# TECH TIP 006

E2/TT006 v1.0  
2014/12

## 6PK1140SF – 6PK1070+T38427

VAG 1.6 DIESEL: CAYB & CAYC + AIR-CONDITIONING

FIG. 1

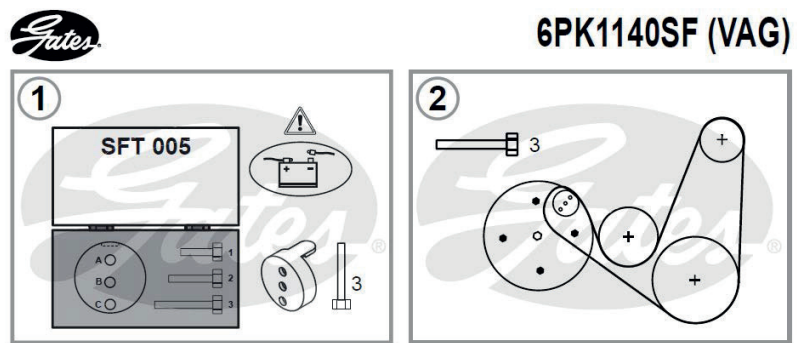
The Gates range includes Stretch-Fit™ belts for earlier applications that have not yet been adapted. Installation instructions and details about the correct tools required are printed on the inside sleeves and are also available from the online catalogue. Fig. 1 shows part of the initial procedure.

FIG. 2

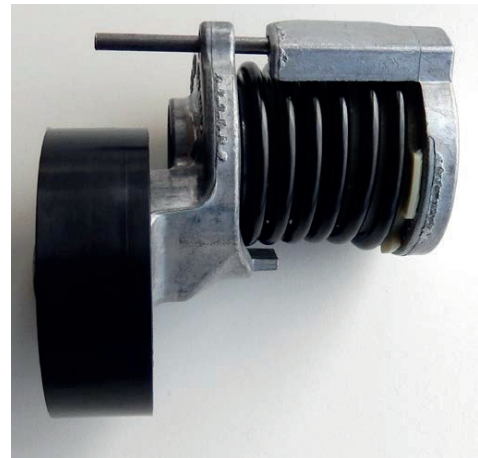
Changes to VAG 1.6 diesel CAYB & CAYC engines affect models equipped with air conditioning, from October 2009 onward. Classic Multi-Ribbed V-belts replace earlier elastic belts.

For models from October 2009 onward, Gates recommends installation of belt 6PK1070 together with tensioner T38427. (Fig. 2 and 3)
